**DEVELOPMENT CONSENT AUTHORITY
LITCHFIELD DIVISION**

AGENDA ITEM: 1 **MEETING DATE:** 16/09/2026 **FILE:** PA2026/0266

APPLICATION PURPOSE: Addition of outbuildings (Carport) and 2 x demountable structures (shipping containers) with a reduced side setback to a single dwelling.

SUBJECT SITE: Section 01957 (5 Benham Ct, Humpty Doo), Hundred of Strangways

SITE PLAN
SET BACK

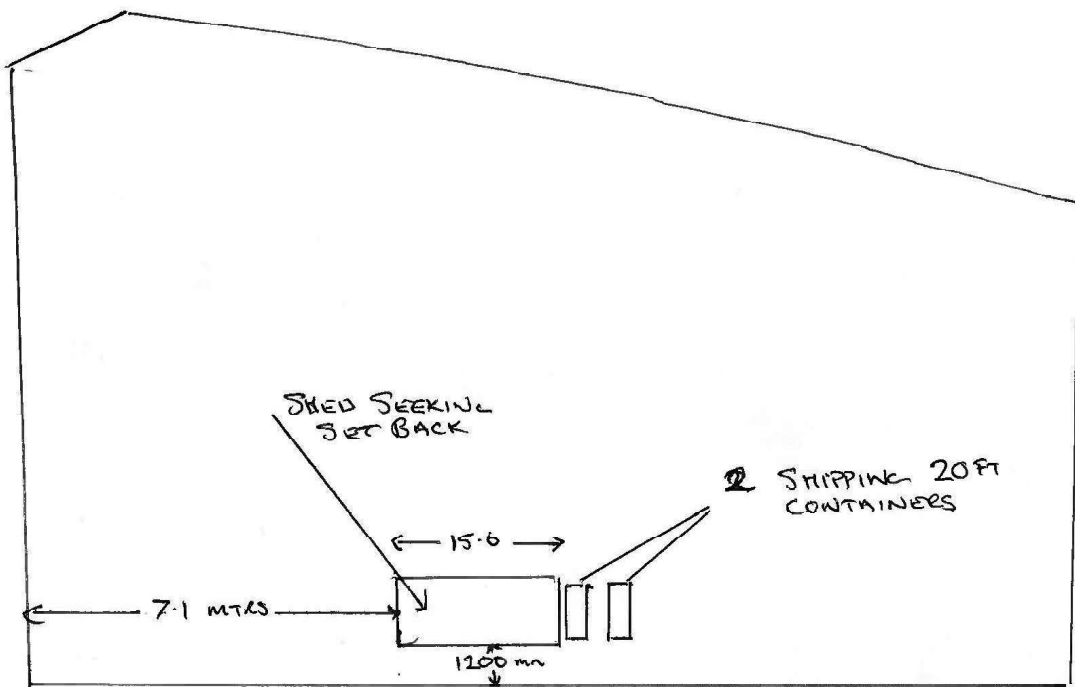
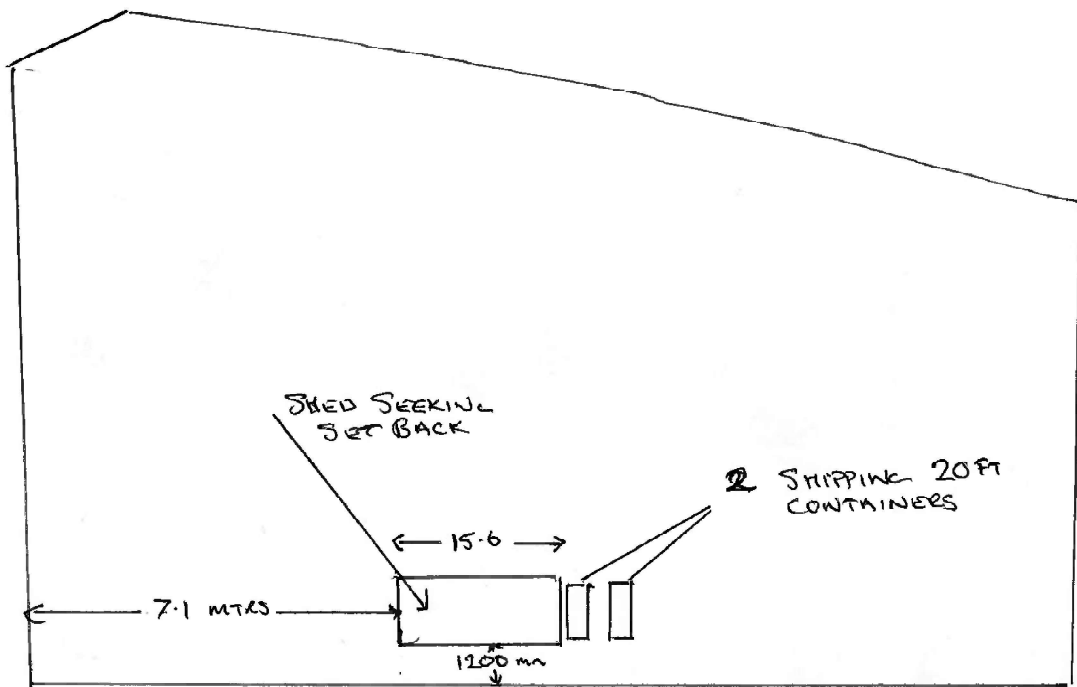
DOES NOT COMPLY, CARPORT IS LOCATED 1.2 MTR
FROM PROPERTY BOUNDARY (0.6 METERS TO ROOF)

1. Carport was built without any Planning approval.
2. I observed the footings being dug approx Nov 2nd and were not very deep. Footings need to be 600mm x 900mm deep, these were nowhere near it when posts were put in.
3. In the event of a cyclone the carport could end up in my property as the footings are not to code and never certified.
4. In the wet season all storm water from carport roof will fall into my property causing me to deal with the storm water.

- It has been assessed that both shipping containers create a significant obstruction within the firebreak.
- The containers will be required to be relocated to provide a minimum **4-metre clearance from the boundary**, in accordance with **Regulation 3 of the Fire and Emergency Regulations 1996**.

- (a) Installation of a gutter along the western edge of the carport/shed to contain water runoff on the property
 - (b) Relocation of the two shipping containers to be at least 10 metres from the western side boundary, whilst remaining compliant with all setback requirements of Clause 5.4.3 of the NTPS 2020.

SHIPPING CONTAINER
PLAN

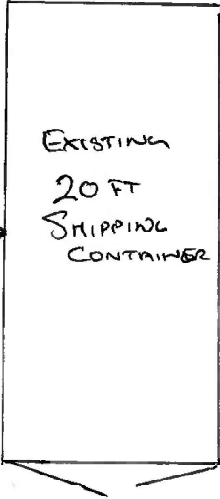
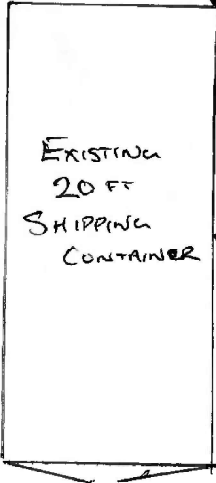
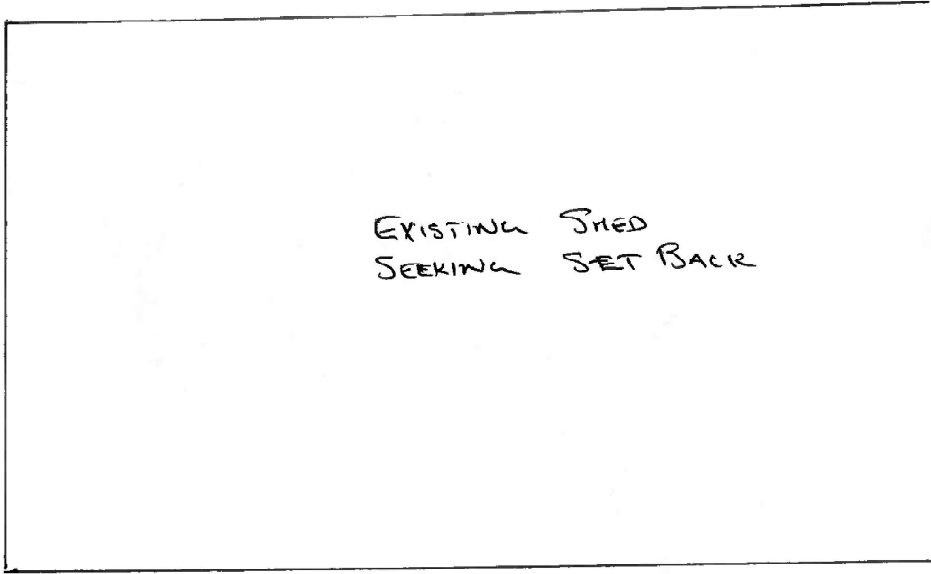
2 DEMOUNTABLES LOCATED 1.2 MTR FROM BOUNDARY

FRONT VIEW

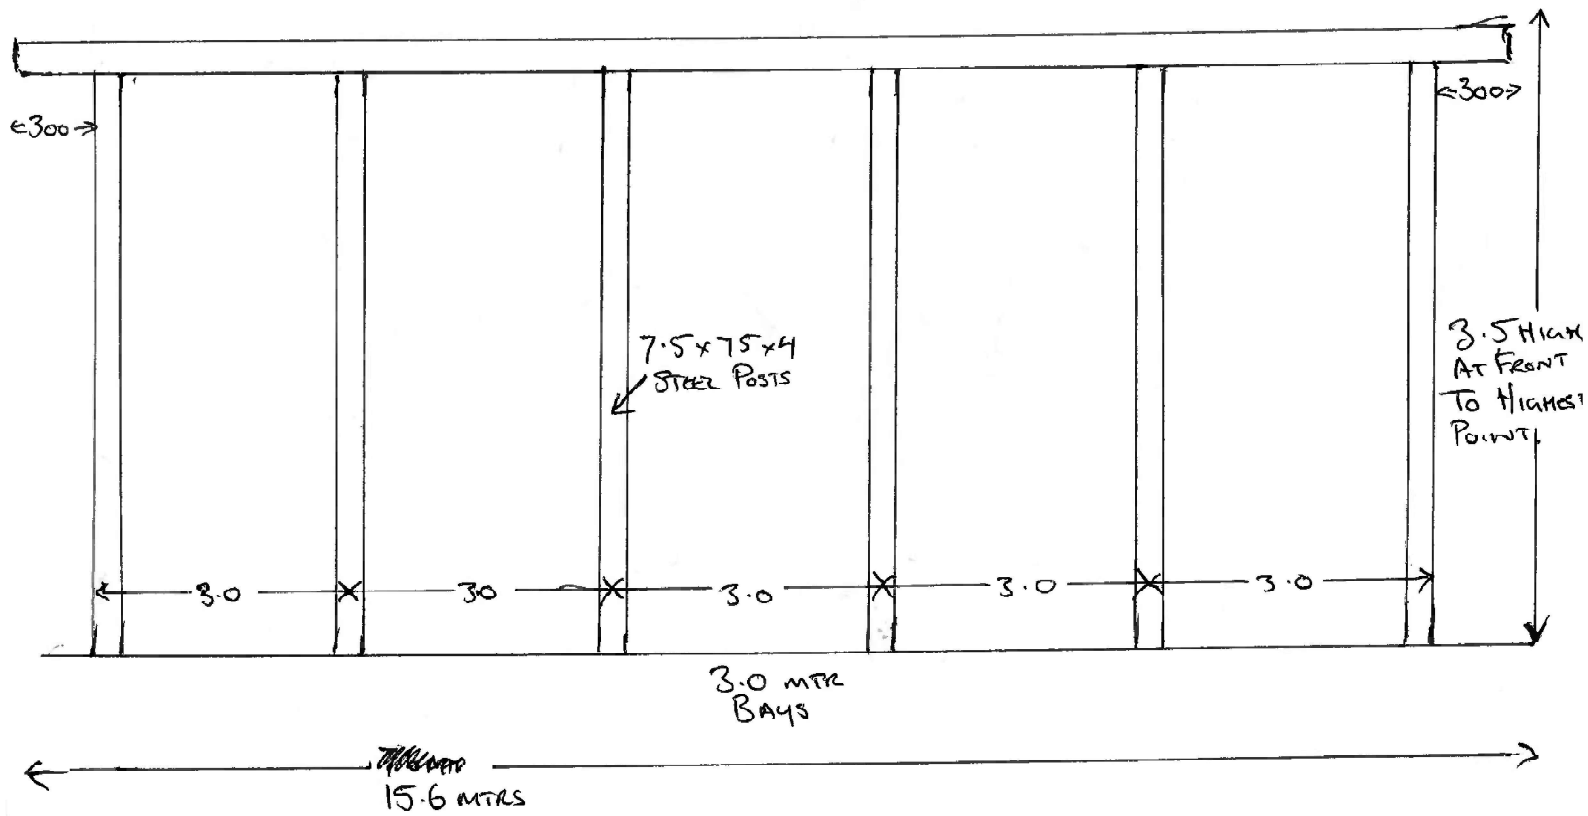
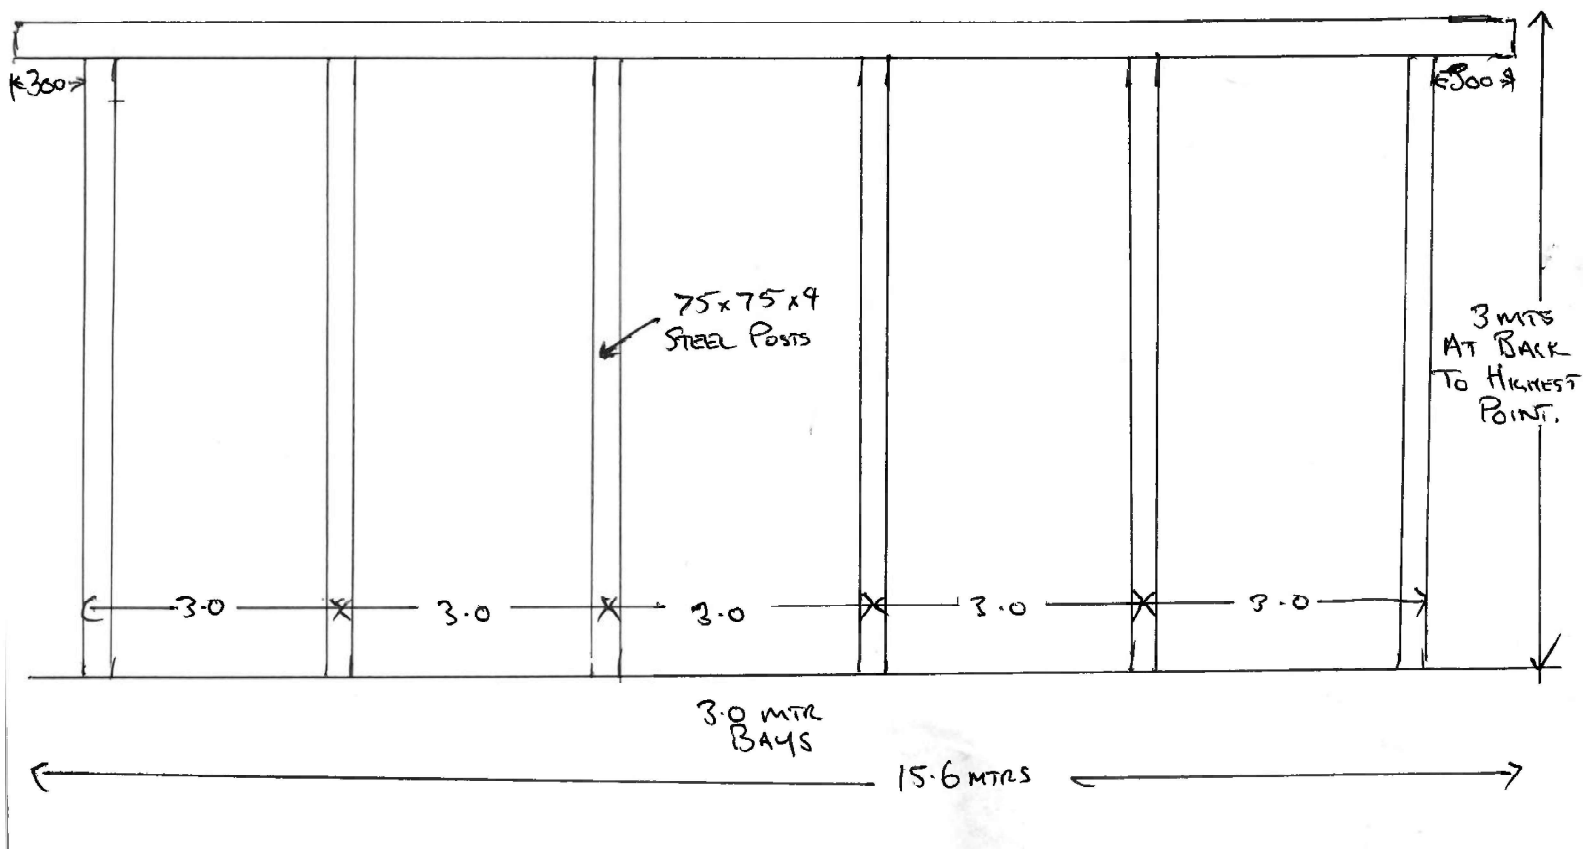
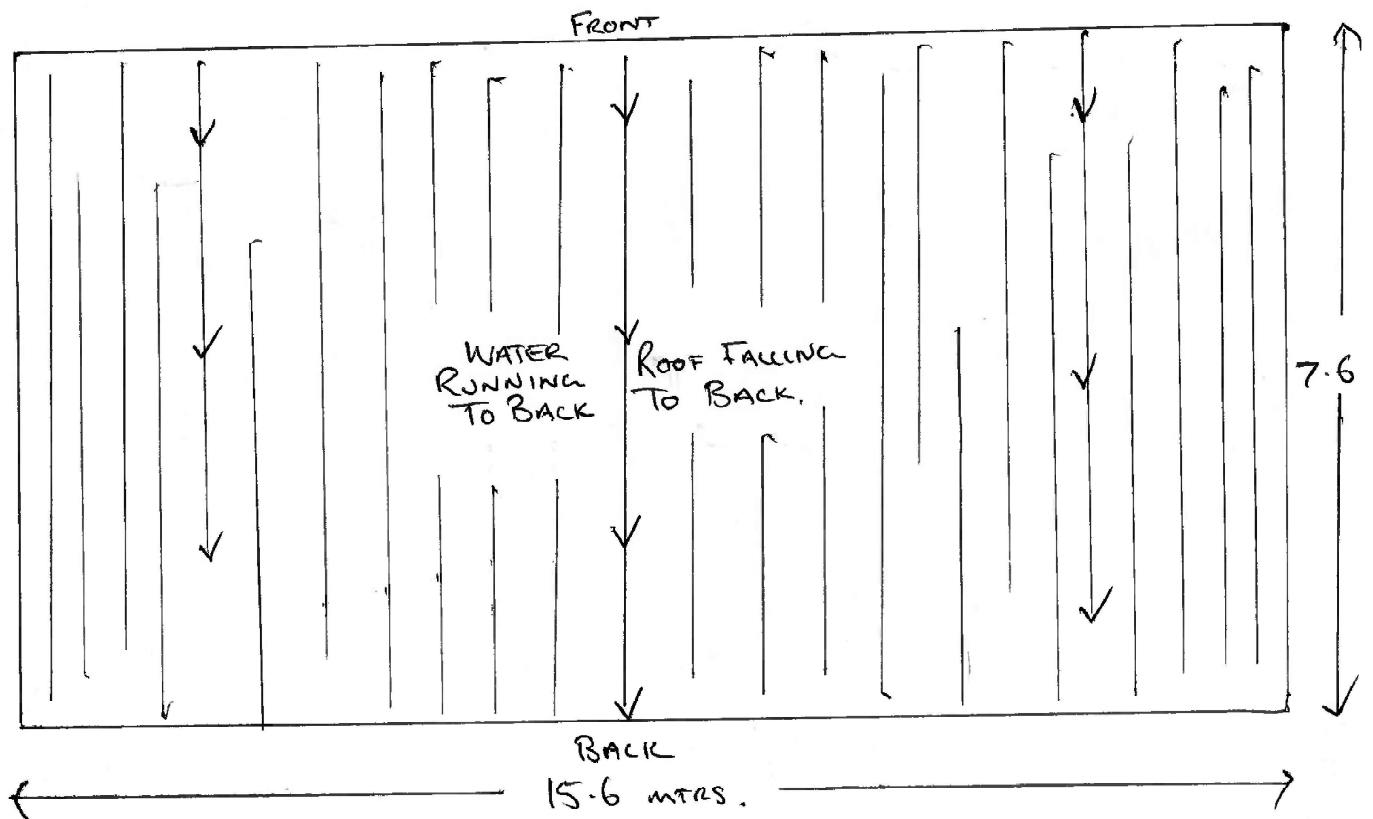
- Council does not support the granting of a Development Permit, as the reduced side setback, particularly in relation to the carport/shed, has stormwater implications for the neighbouring property. This may compromise the integrity of the boundary fence and direct water flows into the neighbouring property. Further, the proposal fails to comply with the required 4 metre firebreaks and presents a fire hazard.
- The property has ample space for additional structures, therefore the outbuildings could be located elsewhere.
- Conditions have been provided, should a development permit be issued.

2. Prior to the endorsement of plans and prior to the commencement of works, a schematic plan demonstrating the on-site collection of stormwater and its discharge into Litchfield Council's stormwater drainage system shall be submitted to and approved by Litchfield Council.
